SUMMARY OF AA-1 SERVICE LETTERS

SERVICE

L
E
T
T
E
R

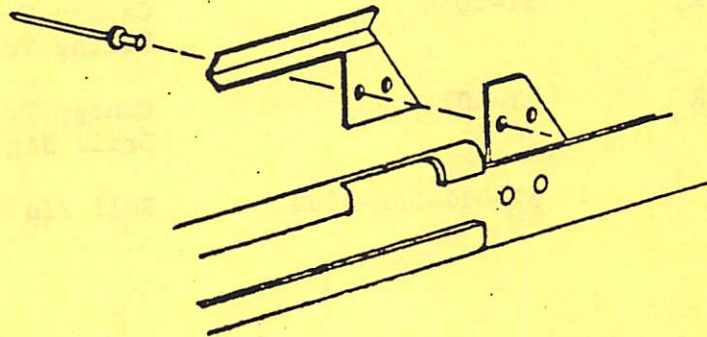
Production aircraft AAL-0190 and up have extended canopy stops installed to limit the rearward travel of the canopy which results in greater support of the canopy track in the forward canopy bow attach area. Extended stops, Part No. 102371-1 and 102371-2, which are secured in place with Part No. 1601-0410 pop rivets, can be installed on aircraft prior to AAL-0190 as illustrated below.

Line up extended stop over existing stop. Drill (2) .136/.139 diameter holes and rivet stop in place. Repeat on opposite track.

Item 3 - Canopy - Windshield Seals

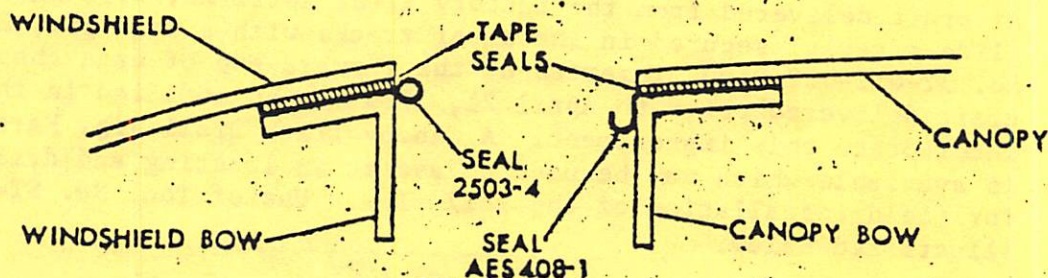
Improved seals at the canopy-windshield junction have been installed on Aircraft AAL-0262 and up and are being supplied for all spares requirements for earlier aircraft. The new windshield seal, Part No. 2503-4, and canopy seal, Part No. AES408-1, are positioned between the plexiglas tape seal and the windshield-canopy bow as illustrated below.

Figure 1. Rudder Bellcrank Modification Procedure.

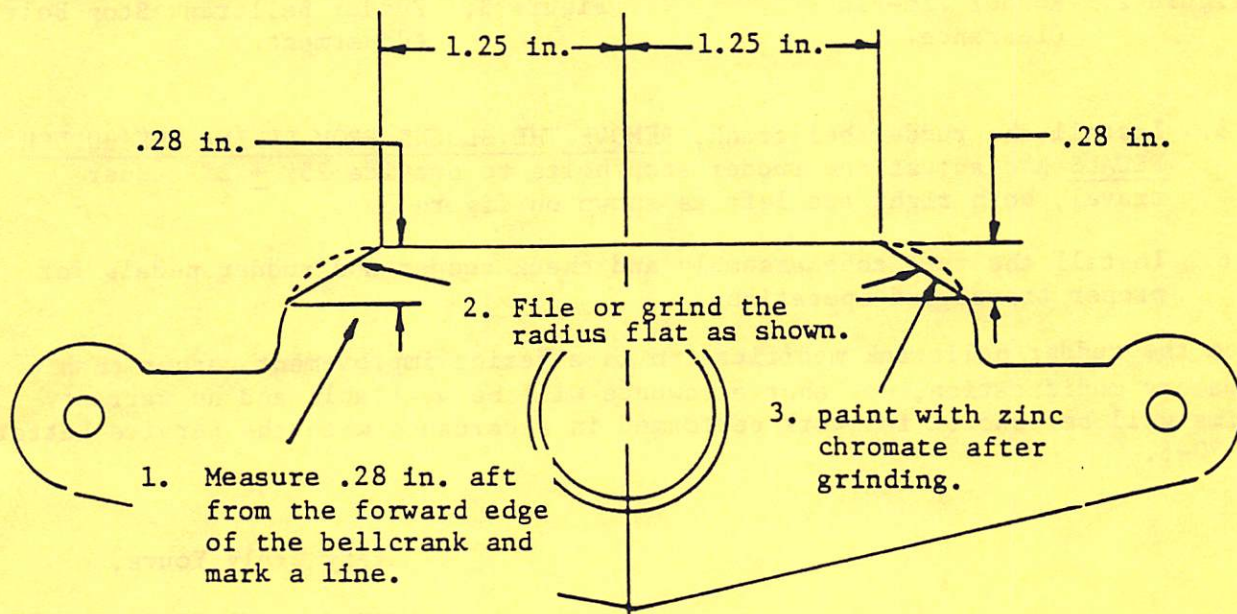
Field reports indicate that on some aircraft a camming action is taking place between the rudder bellcrank and the bellcrank stop bolts due to the radius on the bellcrank at the stop contact point. It is suggested that the bellcrank be modified to provide a flat contact area between bellcrank and stop bolts at the next scheduled inspection, or sooner at the owner's discretion.

3. Rework the rudder bellcrank as shown on figure 1.

Figure 2. Rudder Tip-Fin Clearance.

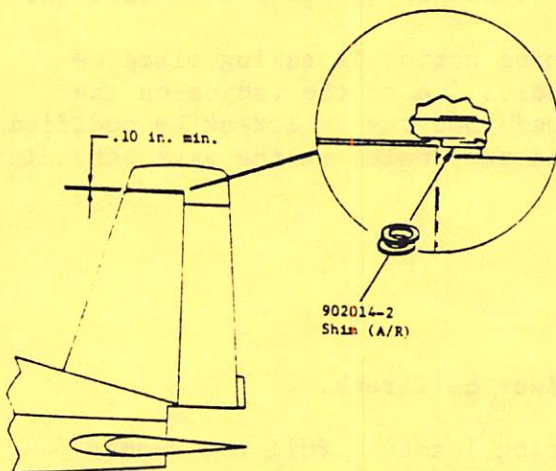
4. Prior to installation of the rudder bellcrank, check the clearance between the rudder tip and fin. Minimum clearance is 0.10 inch as shown on figure 2. If clearance is less than 0.10 inch, install shims part number 902014-2 as required. Lubricate the rudder bearings, as required, with Aeroshell grease #6 or equivalent per MIL-G-7711.

Figure 3. Rudder Bellcrank Stop Bolt Adjustment.

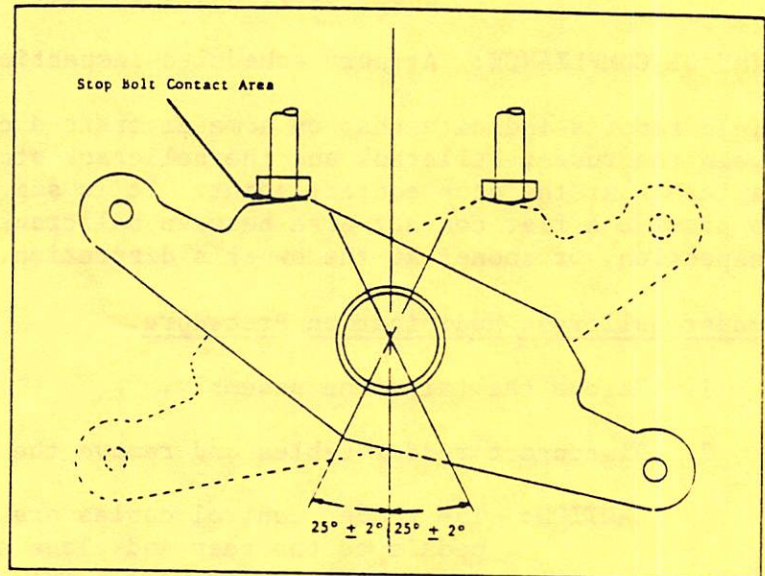
5. Install the rudder bellcrank, REMOVE THE BLOCKS FROM BEHIND THE RUDDER PEDALS and adjust the rudder stop bolts to provide $25^\circ \pm 2^\circ$ rudder travel, both right and left as shown on figure 3.
6. Install the tail cone assembly and check rudder and rudder pedals for proper travel and operation.

Figure 1. Magneto Lead Isolation

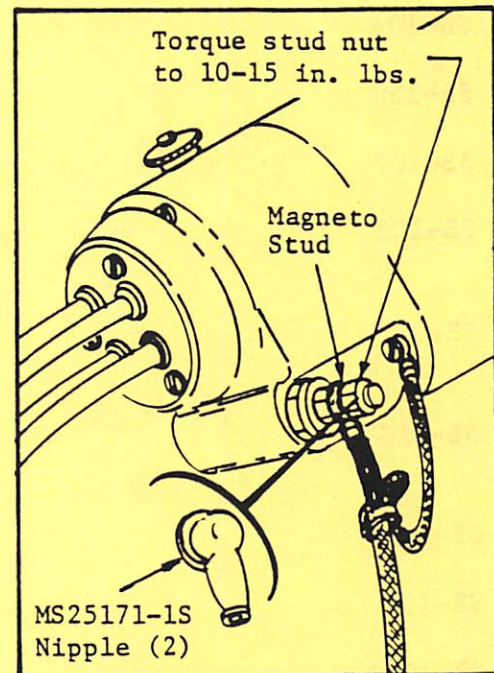
Magneto Lead Isolation Procedure (Figure 1)

1. Disconnect the leads from each magneto stud.
 2. Slide a nipple (MS25171-1S) over each lead and reconnect leads to magneto studs.
- NOTE: Torque the magneto stud nuts to 10-15 in. lbs. Do not over torque as stud may be pulled from capacitor.
3. Slide the nipple over the magneto studs.
 4. The shielding on the magneto lead is pulled back, looped and tied as shown on figure 1. Be sure the loop is pulled back and tied securely Loop must be outside of nipple.
 5. Run up engine and check for normal magneto and switch operation.

Figure 1. Seat Track Modification

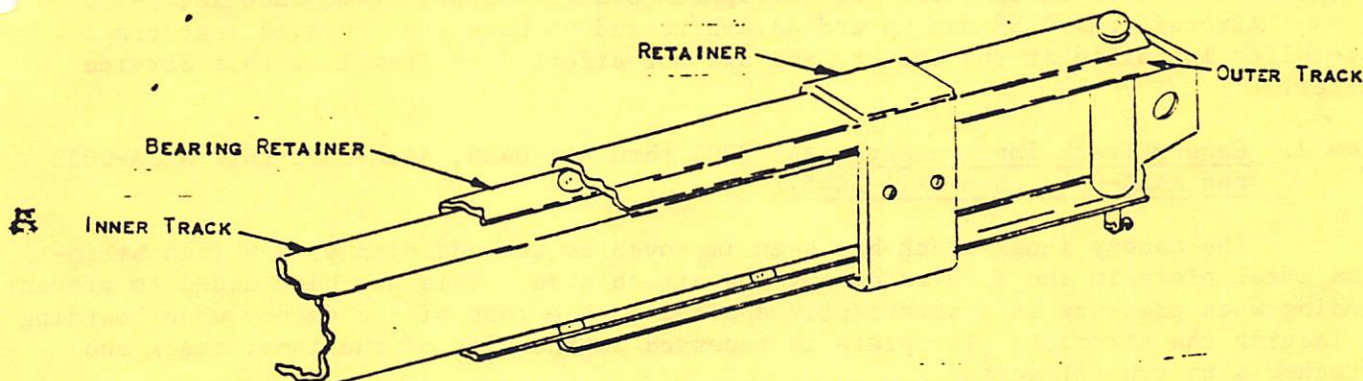
Improved seat track assemblies have been developed which incorporate retainers (3 per seat), riveted to the ends of the inner track and enclosing the outer track. The retainers prevent the outer track from springing and twisting when excessive aft loads are exerted against the seat back (see figure 1).

Figure 2. Canopy & Windshield Hardware Improvement

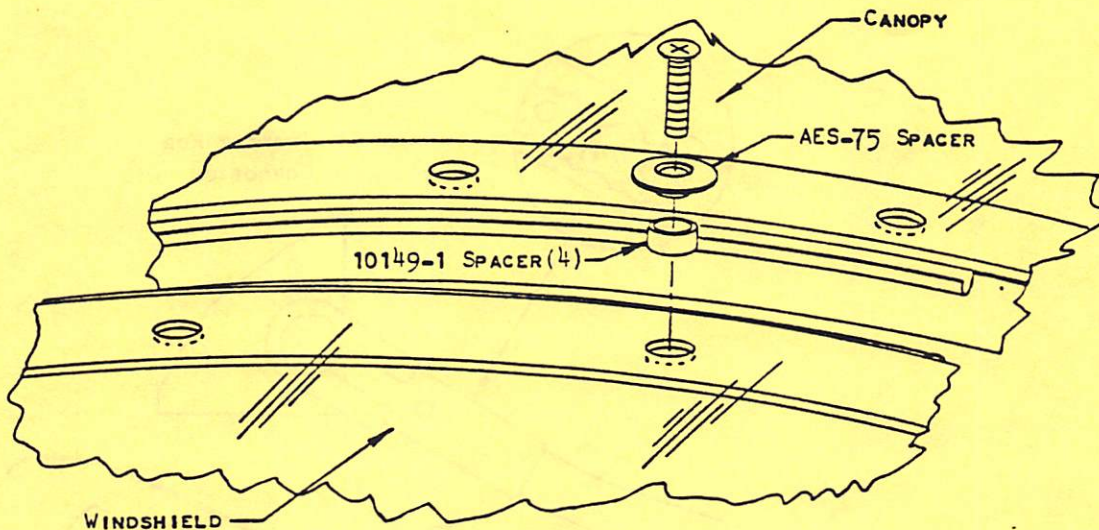
Improvements in the windshield/canopy hardware have been made which provide better sealing of the canopy to the windshield by preventing movement of the bows when latching the canopy. The improved hardware consists of four (4) spacers, part no. 10149-1 which are installed in the two top holes of the windshield and the two top holes of the canopy only (see figure 2).

Spacers, part no. 10149-1 can be ordered (no charge), from your American Aviation Corp. dealer, four (4) required per aircraft. Aircraft not shown on the above serial no. list, do not require the installation of the spacers.

Figure 3. Nose Gear Inspection

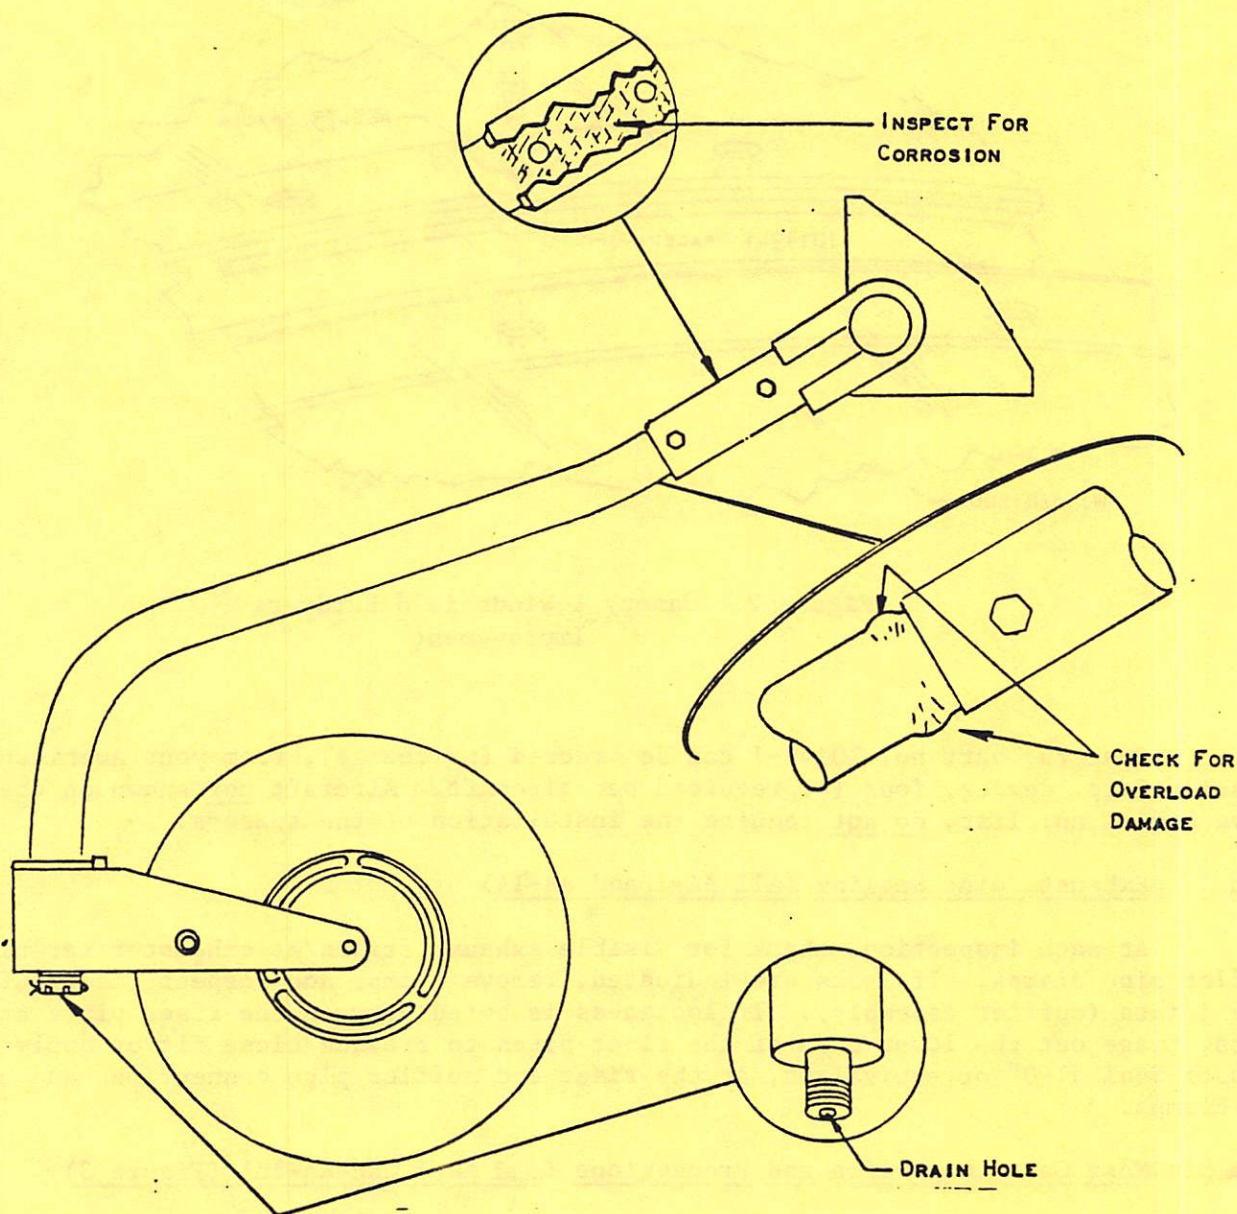
Item 5. Nose Gear Inspection and Precautions (All AA-1 and AA-1A) (Figure 3)

- a. Loosen nose gear boot and inspect strut for evidence of overload damage in the area shown:
- b. Check strut for looseness in torque tube yoke. If loose, replace bolts (NAS464P6A28). If new bolts do not eliminate looseness, ream to next larger size NAS bolt (NAS464P7 maximum).
- c. Check drain hole at lower end of strut to insure it is open. One method is by running a .125" drill bit through the hole to clean out any foreign material that may inhibit draining.
- d. Remove strut at each annual inspection and inspect for corrosion in the strut to torque tube yoke joint. Reseal per item 6.

Figure 4. Nose Gear Strut Sealing

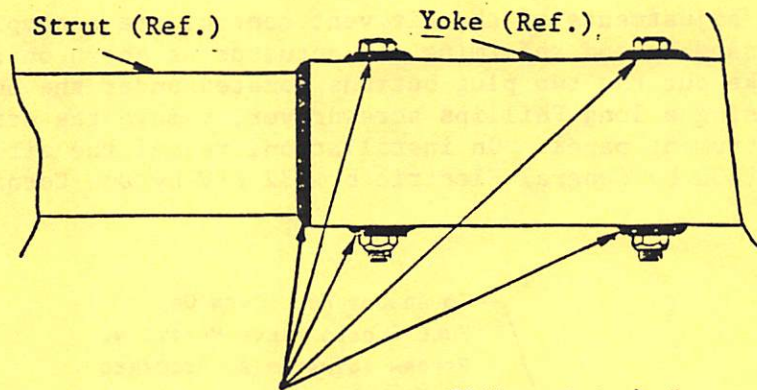
At next inspection and any time strut is removed, it is recommended that the nose gear strut be sealed at the strut/torque tube yoke joint to prevent water from entering the strut from inside the cabin. Clean the area thoroughly and apply sealant* to the joint and around bolt heads as shown on figure 4.

Apply sealant (RTV 102 by General Electric or 732 RTV by Dow-Corning) on bolts and strut to torque tube connection. At next inspection and any time strut is removed.

Figure 5. Air Vent Control Shaft Spacer

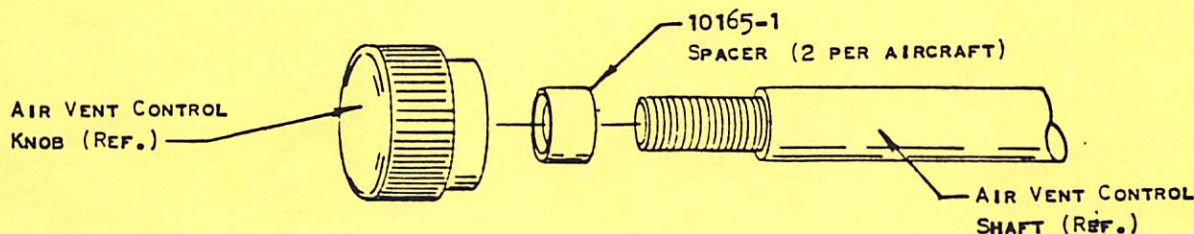
To provide more control rod travel toward the closed position, a spacer, part no. 10165-1, has been added on current production aircraft, between the shaft shoulder and the control knob. This provides 1/4 inch more rod travel and assures the valve fully closing when properly adjusted. Spacer, part no. 10165-1 can be ordered (no charge), from your authorized American Aviation Corporation dealer.

Figure 6. Air Vent Sealing and Adjustments

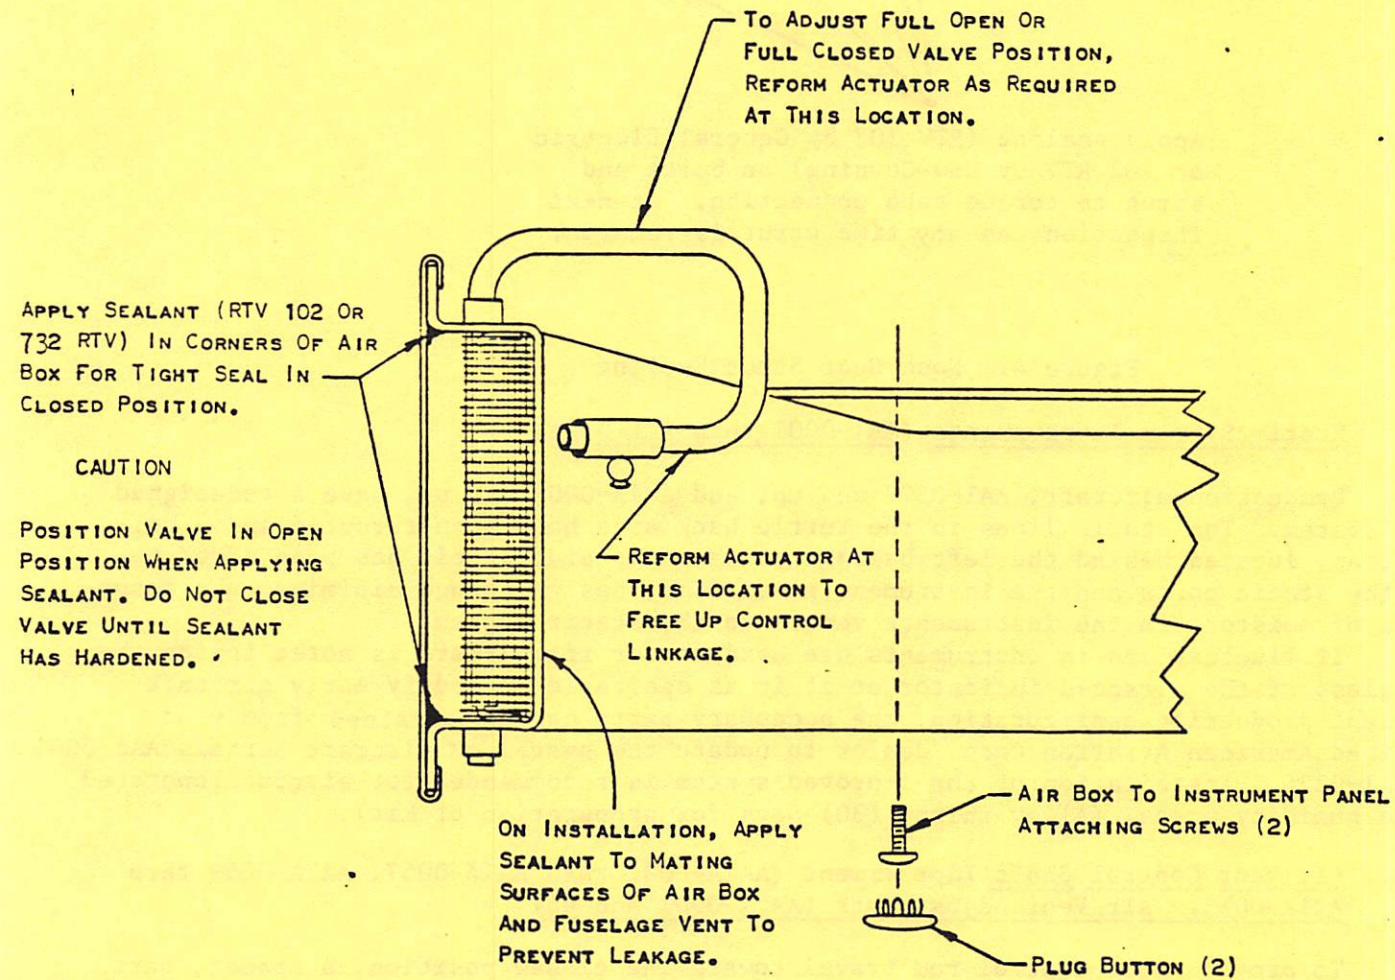
If required, adjustments of the air vent control are accomplished by removing the air vent assembly and reforming the actuator as shown on figure 6. To remove the airbox, take out the two plug buttons located under the box, (figure 6) near the front, and using a long Phillips screwdriver, remove the screws attaching the airbox to the instrument panel. On installation, reseal the airbox to the fuselage with sealant (RTV102 by General Electric or 732 RTV by Dow Corning).

Figure 1. PK Screw Locations

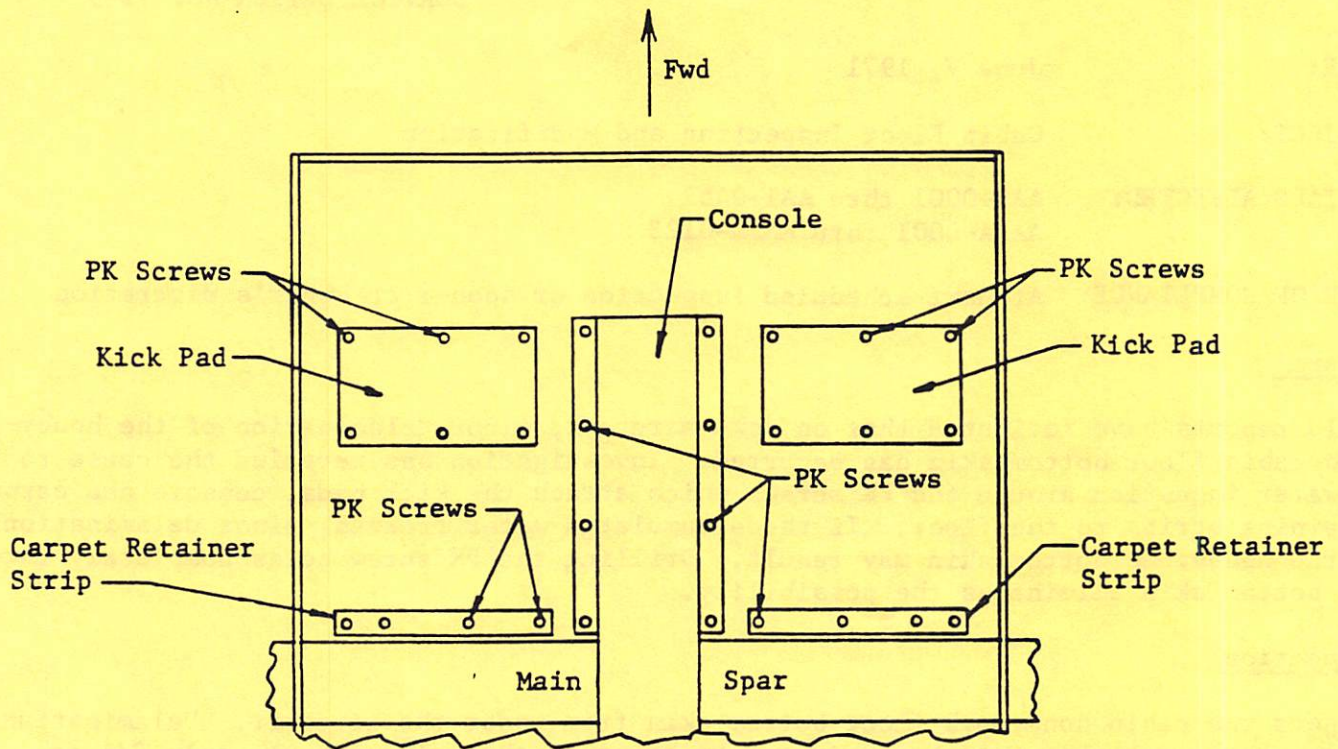
It is recommended all PK screws in the cabin floor forward of the main spar (Figure 1) be removed, one at a time, and the holes be drilled through the bottom skin from the top using a #40 (.098") drill. This will allow any water entering around the PK screws to drain. After drilling each hole through bottom skin, reinstall the PK screw before proceeding to next screw. This will help maintain alignment and prevent possible enlargement of the screw holes. After all screw holes have been drilled through bottom skin, insert the shank end of the #40 drill in the hole from underneath and push drill aft to provide a lip on the forward edge of hole. (See Figure 2).
